SNOWPLOWS

SERVICE BULLETIN NO. 26

81018, 81023 and 17120 Mountings

2001 & Later Chevrolet C/K 2500/3500

17120 MDII Mount
Part No. 11812 RH Side Mount

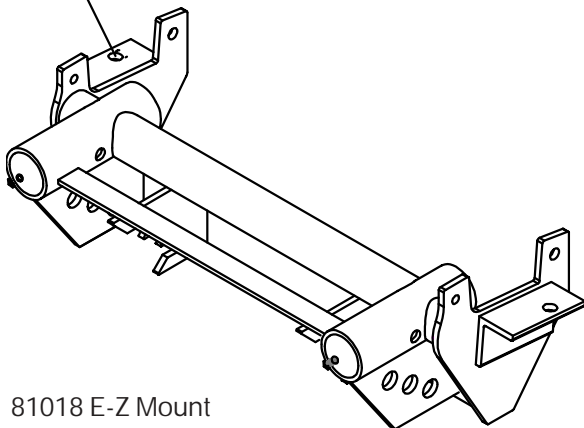
Hole will need to be slotted 1/4" to the rear of vehicle

81018 E-Z Mount
Part No. 80339 Clevis

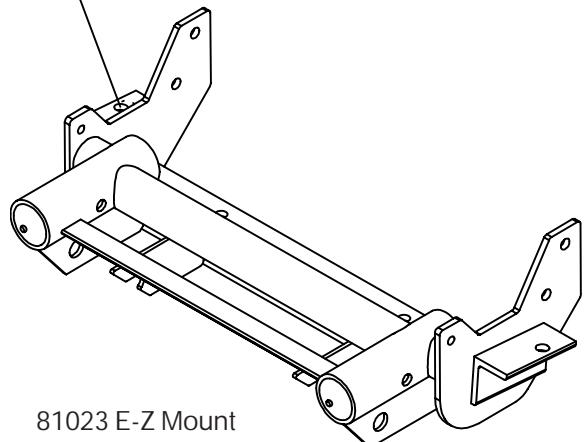
Hole will need to be slotted 1/4" to the rear of vehicle
